Entergy Nuclear Operations, Inc.  
Vermont Yankee  
320 Governor Hunt Rd  
Vernon, VT 05354  
Tel 802 257 7711

BVY 13-097

SUBJECT: Technical Specifications Proposed Change No. 306  
Eliminate Certain ESF Requirements during Movement of Irradiated Fuel  
Vermont Yankee Nuclear Power Station  
Docket No. 50-271  
License No. DPR-28

Proposed Change 306

BASES: 3.2.C/4.2.C REACTOR BUILDING VENTILATION ISOLATION AND STANDBY GAS  
TREATMENT SYSTEM INITIATION

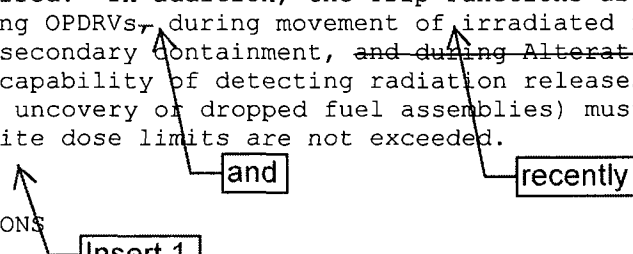
have originated from the primary containment due to a break in the RCPB or the refueling floor due to a fuel handling accident. When High Reactor Building Ventilation Radiation or High Refueling Floor Zone Radiation is detected,

secondary containment isolation and actuation of the SGT System are initiated to support actions to limit the release of fission products as assumed in the UFSAR safety analyses (Ref. 4).
